SUMMARY OF CONCERNS IN RELATION TO THE PROPOSED NORTHCONNEX TUNNEL

This is an objection to many aspects of the proposed NorthConnex tunnel.

SECTION A: THE CONNECTIVITY OF NORTHCONNEX SOUTHERN VENTILATION FACILITY AT THE SOUTHERN INTERCHANGE, THE SOUTHBOUND TUNNEL IN PARTICULAR

MOTORWAY OPERATIONS COMPLEX - SOUTHERN VENTILATION FACILITY - SECTIONS
M1-M2-5000-DR-JD-0525

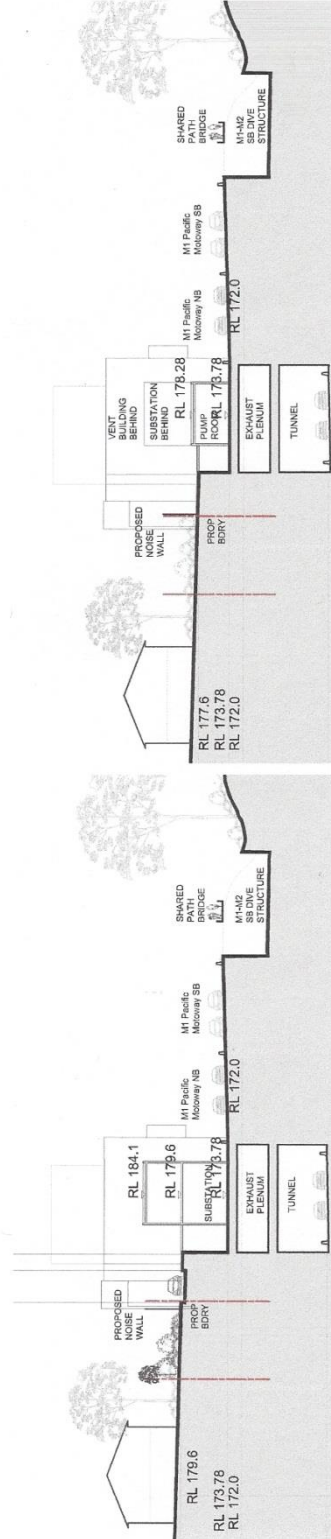
5. *EIS Volume 4, Technical working papers - Urban Design, 6.0 Operational Ancillary Facilities*
EIS Page 99 there is the diagram "Motorway Operations Complex – Southern Ventilation Facility – sections. *Page 10 below* The diagram has the cryptic label "Connection to tunnel TBC". What does TBC stand for? To be considered? Why is tunnel singular? Which tunnel is the diagram referring to northbound or southbound? There is no diagram showing any connection from the Southern Interchange ventilation facility to either the northbound or the southbound tunnel in any way
AND YET

- Diagrams need to be provided showing the inter-relation between the shaft, the ventilation outlet and the motorway operations centre with a clear description of what is to be constructed and how it will operate.
- The community needs irrefutable evidence that the polluted air from the southbound tunnel exit portals will not be allowed to flow like an invisible sewer through West Pennant Hills, North Rocks, Carlingford and Beecroft.

M1-M2-5000-DR-UD-0550
NORTHERN VENTILATION FACILITY - CROSS SECTIONS

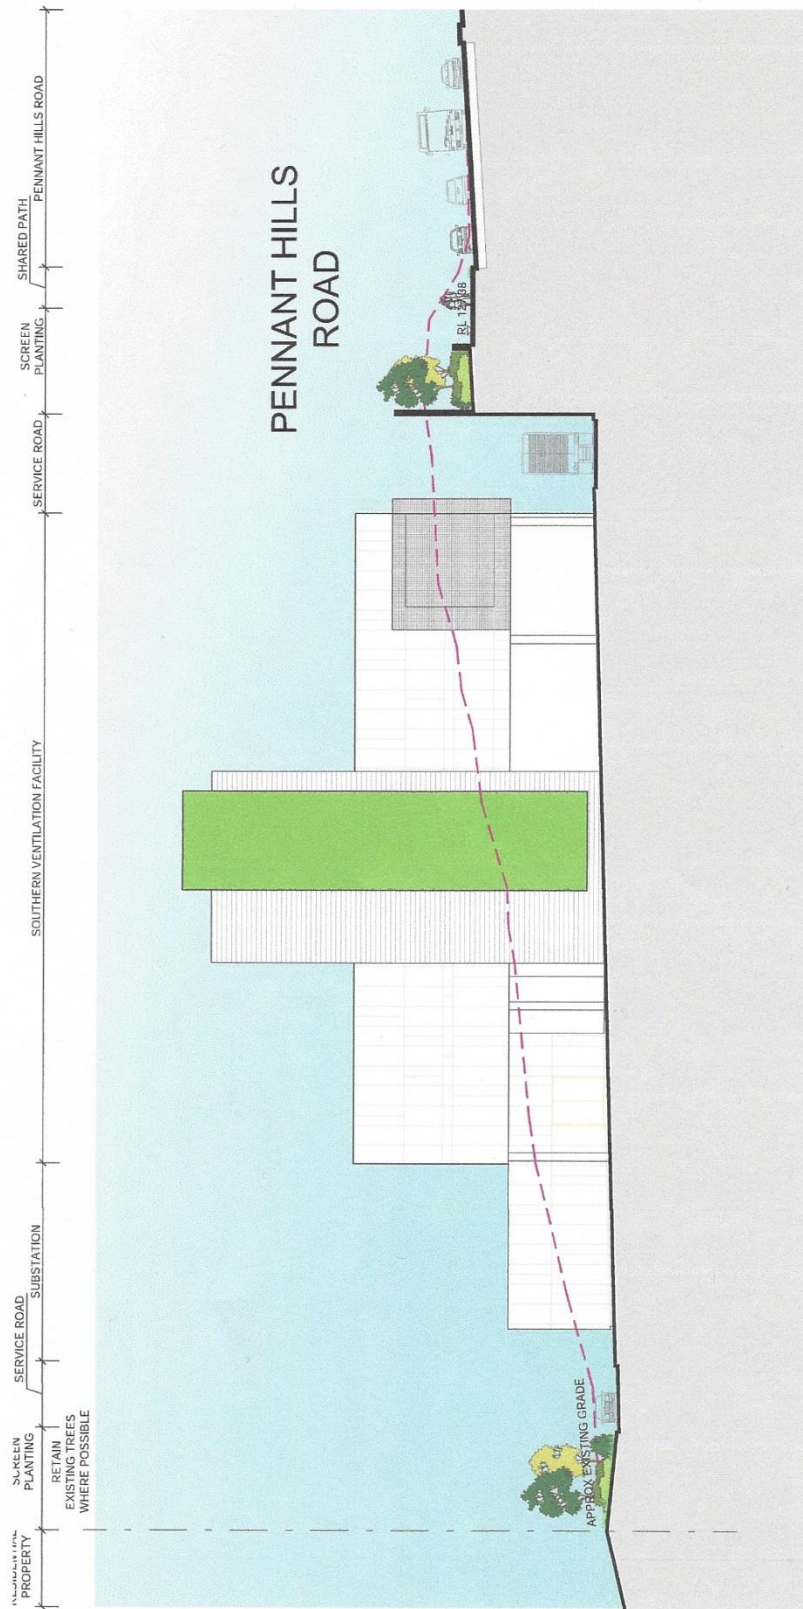
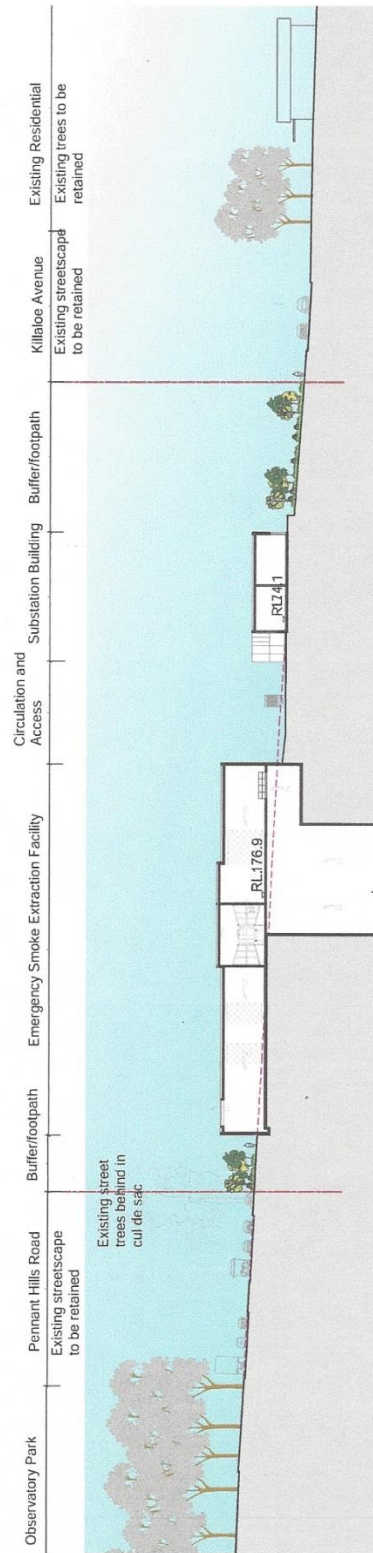
EIS page 135 *Page 11 below* there is a very explicit diagram showing the *Northern Ventilation Facility – cross section*.

EIS page 134 *Page 12 below* there is a very explicit diagram showing the *Northern Ventilation Facility – long section*.

Why are there no comparable diagrams for the Southern Interchange and the Southern Ventilation facility?
